**FINAL DRAFT  
REPORT**

**Clarksburg - Ten Mile Creek Area  
Sewer Facility Study**

Washington Suburban  
Sanitary Commission

March 2, 2015

**Figure 1-1  
Project Study Area in Seneca Creek Basin**

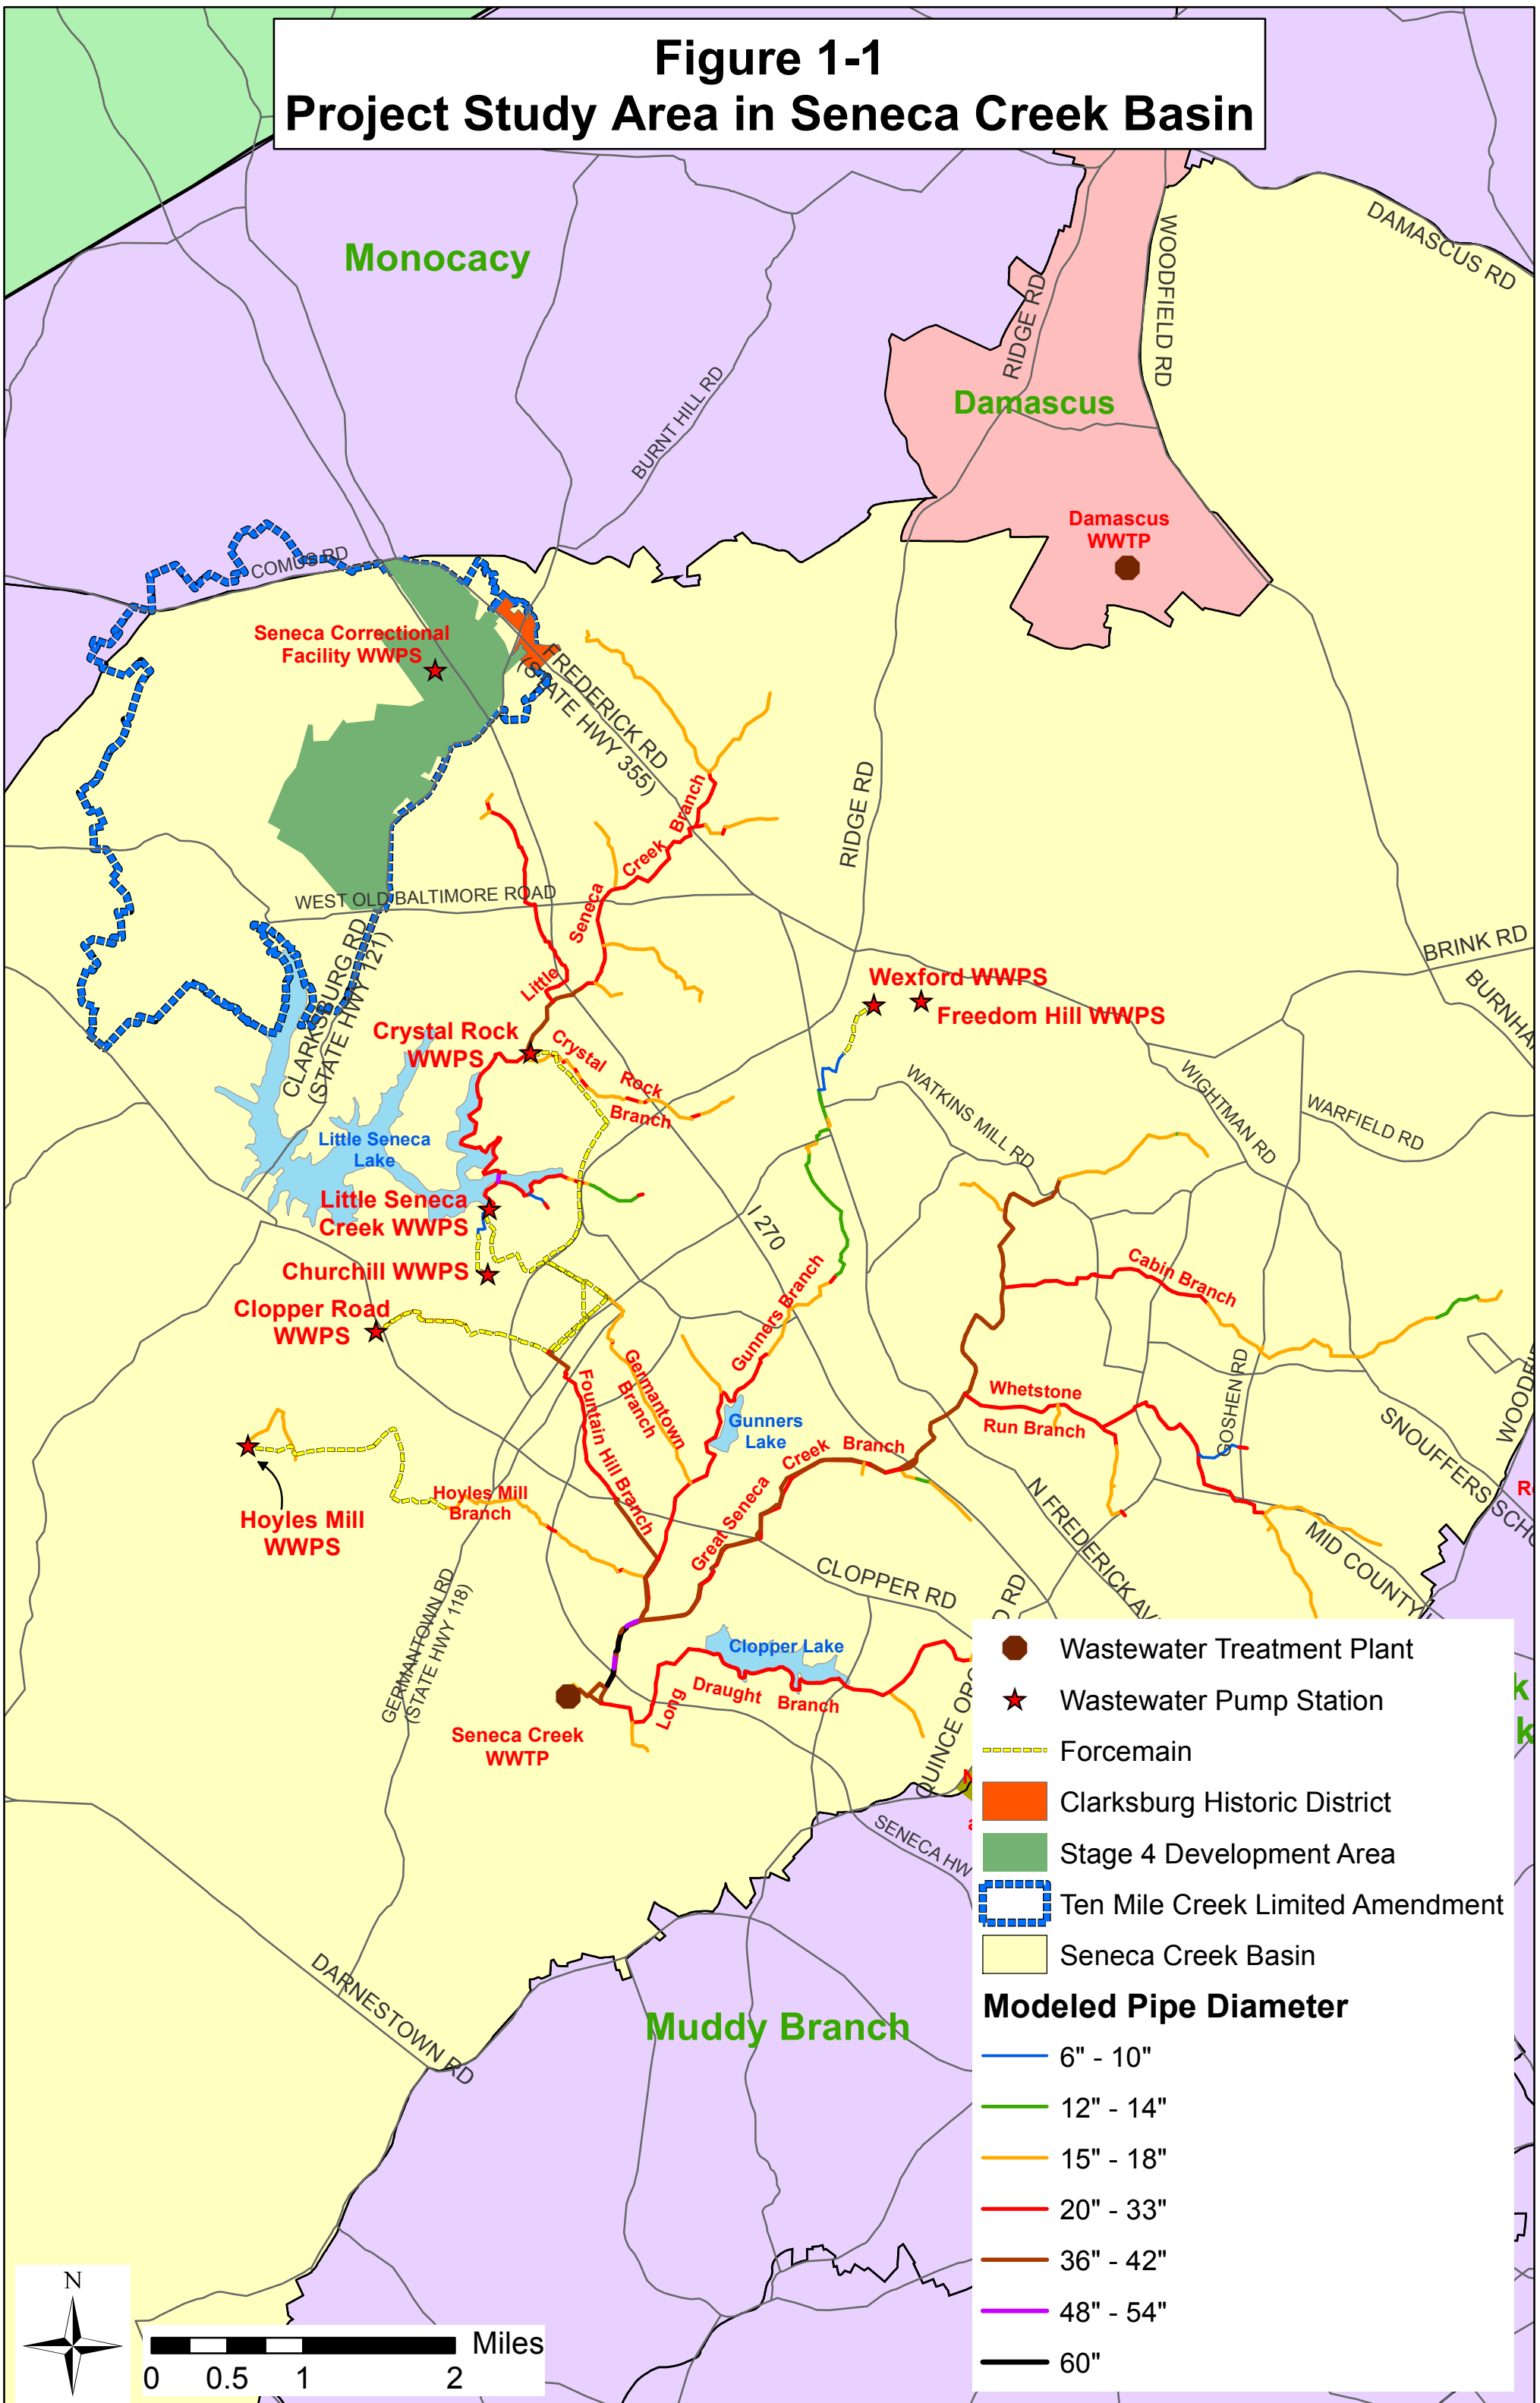
11	12/18/2015	Dave Lake (MCDEP)	<i>Figure 1-1: The Project Study Area need a companion map that identifies the TMC and tributaries as Figure 1-1 does for the downstream areas.</i>	An additional companion map ( <i>New Fig 1-2</i> ) is included in the Final Draft Report to address the comment.
12	12/18/2015	Dave Lake (MCDEP)	<p>Figure 1-2:</p> <ul style="list-style-type: none"> <li><i>This figure should include all of the Study Area and not be partially blocked by the table heading. It appears map legend for the Historic District Vicinity Properties is not accurately depicted.</i></li> <li><i>Legend colors and designations should align better.</i></li> </ul>	Figure 1-3 ( <i>Figure 1-2 in Working Draft Report</i> ) of the Final Draft Report includes extent and legend modifications to address comment.
13	12/18/2015	Dave Lake (MCDEP)	<i>Figure 1-4: Cabin Branch is two different colors with no explanation.</i>	Figure 1-4 (of the Working Draft Report) has been deleted from the Final Draft Report since it relies on outdated information.

# Figure 1-3 Study Area and Downstream WSSC Sewers

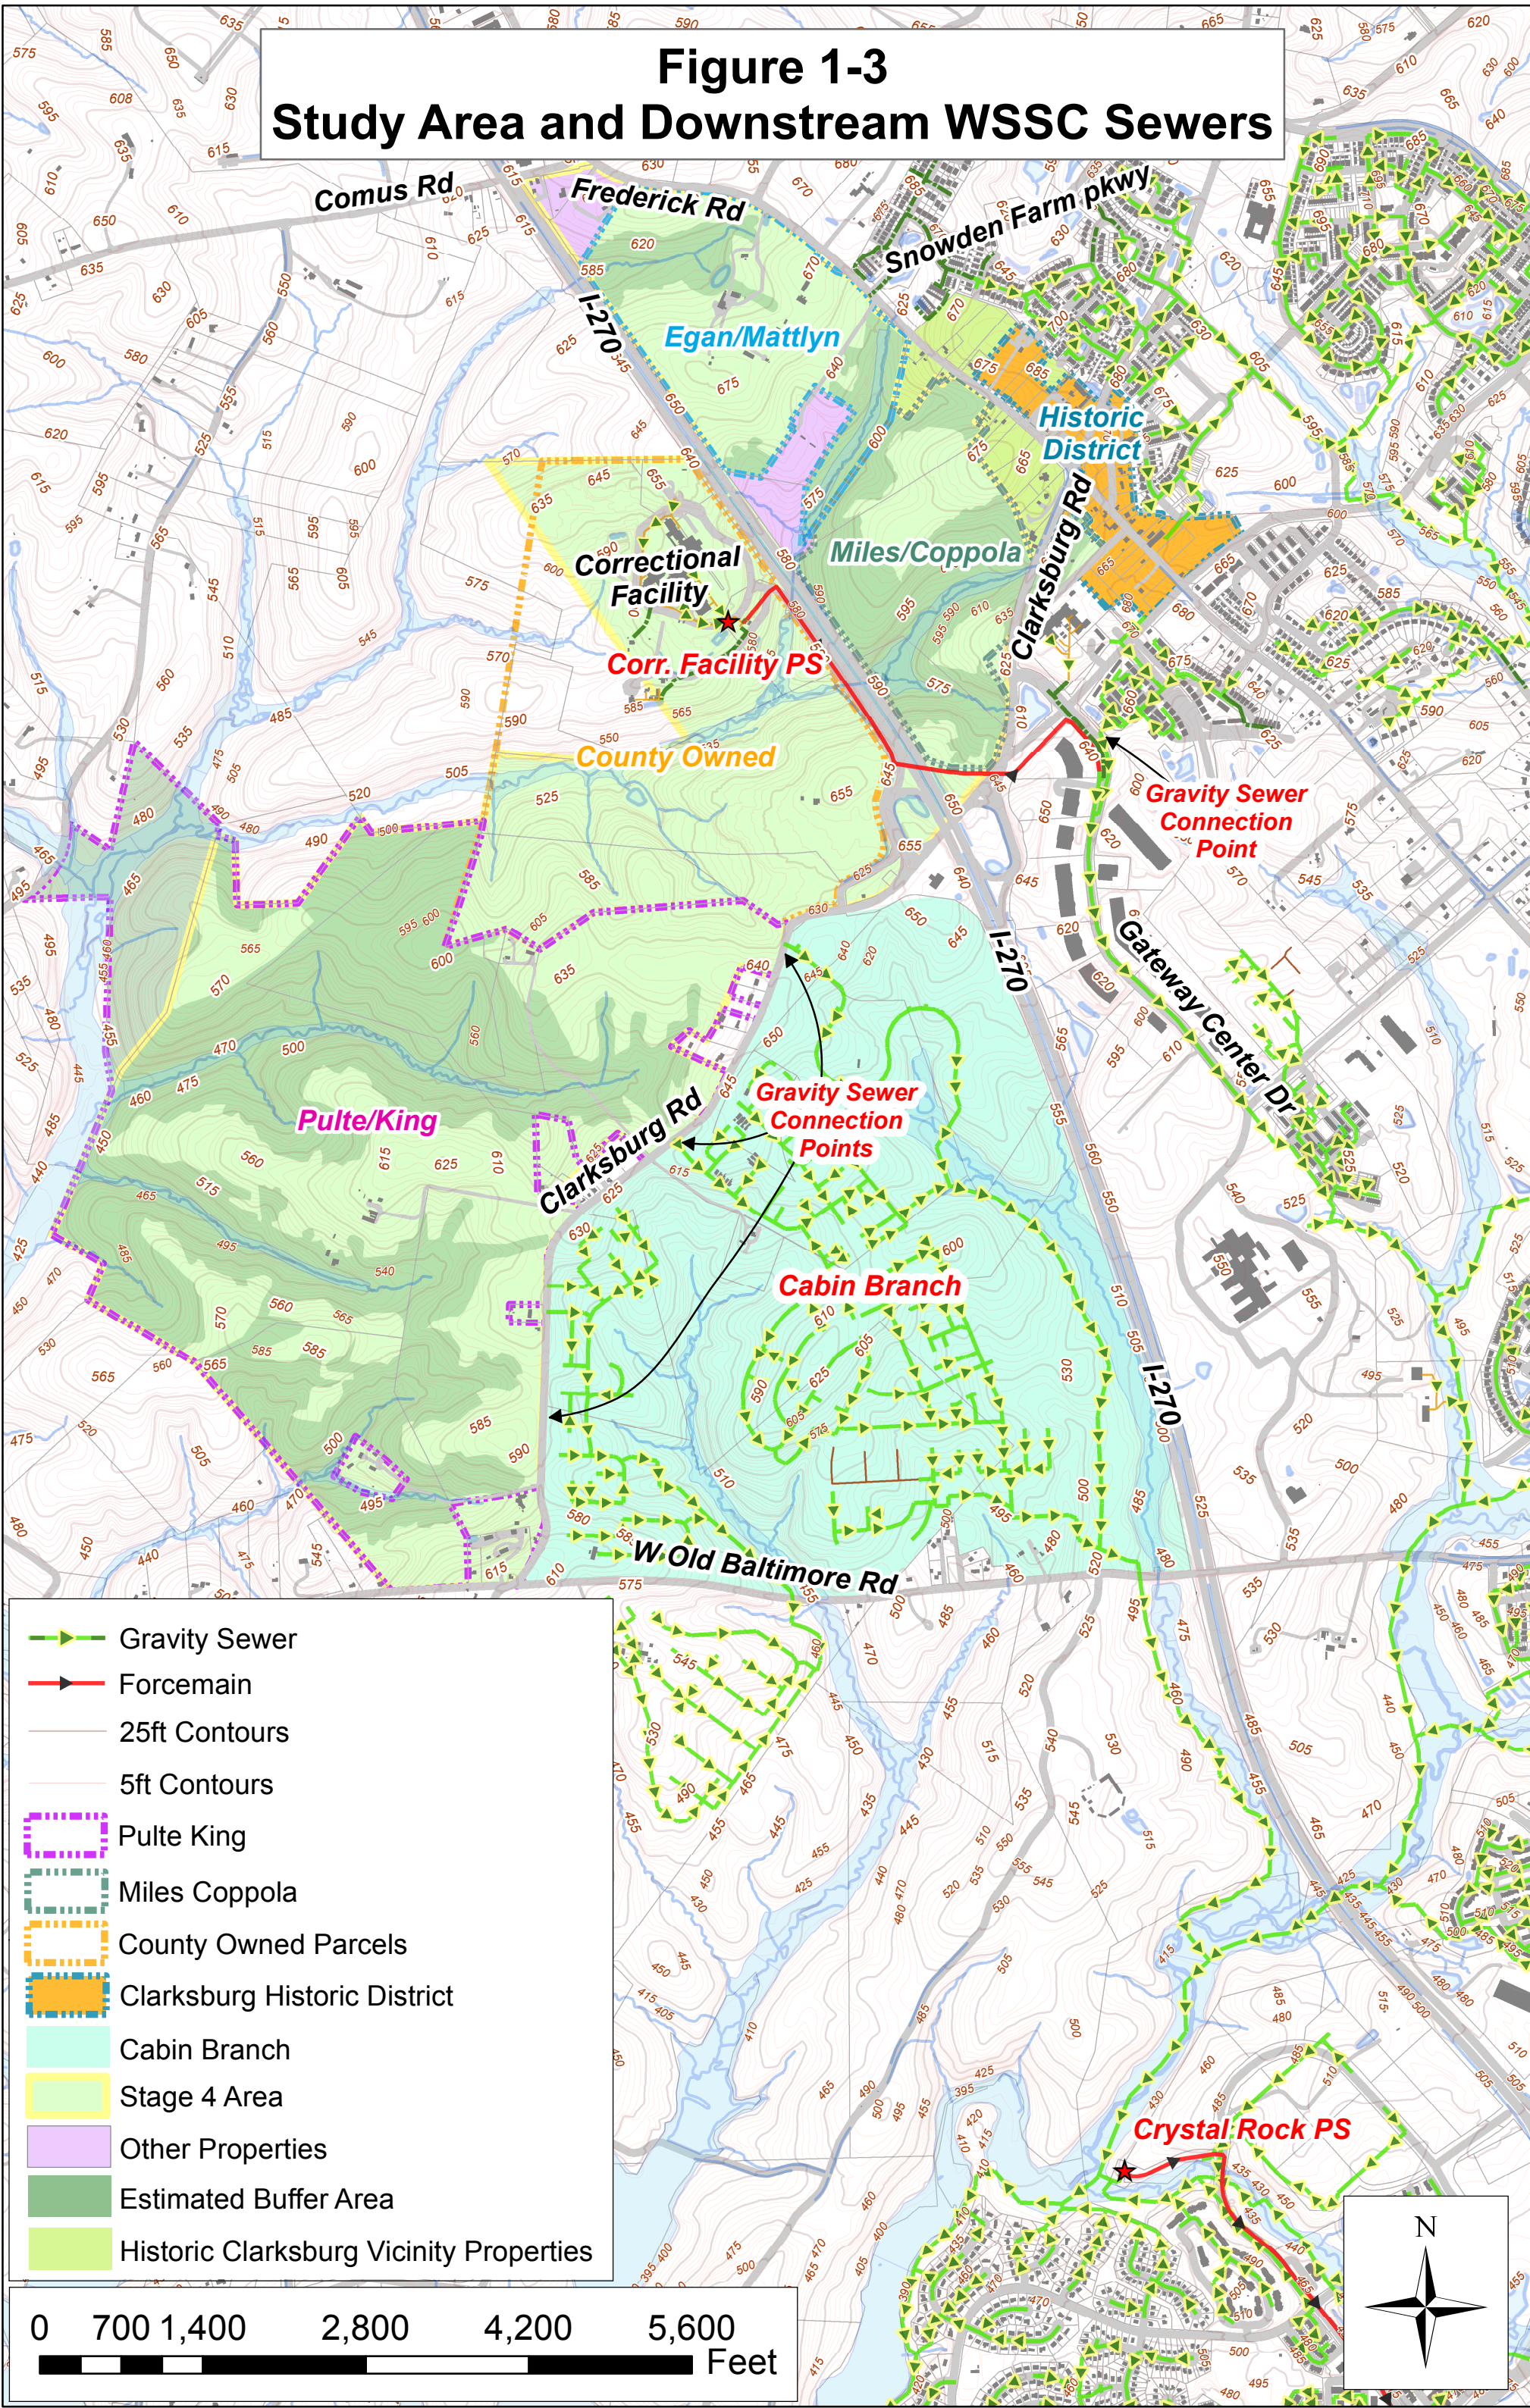
Number	Date	Representative/Party	Comment	WSSC Response
		Anne James, Cathy Wiss, (CAC Members)	<i>d) In Figure 1-3, WSSC shows anticipated bottlenecks in the gravity sewers along Gateway Center Drive. What are the plans to alleviate them?</i>	When new development plans are submitted to WSSC for review and approval, a Hydraulic Planning Analysis (HPA) is conducted to review available capacity in the downstream sewers and determines the necessity for a relief sewer. At this point in the process WSSC does not have the necessary information to determine when such a relief sewer may be needed.
<b>42</b>	12/21/2015	Katherine E. Nelson Planner Coordinator M-NCPPC	<i>1. Section 1, Page 1-3 - County Owned Properties – 220 forested acres of correctional facility are protected by a permanent conservation easement. Also, the future planned expansion is limited in scope and takes place within the current cleared area of the site. The County owns two vacant parcels that are not part of the correctional facility.</i>	Section revised in Final Draft Report to address the comment.
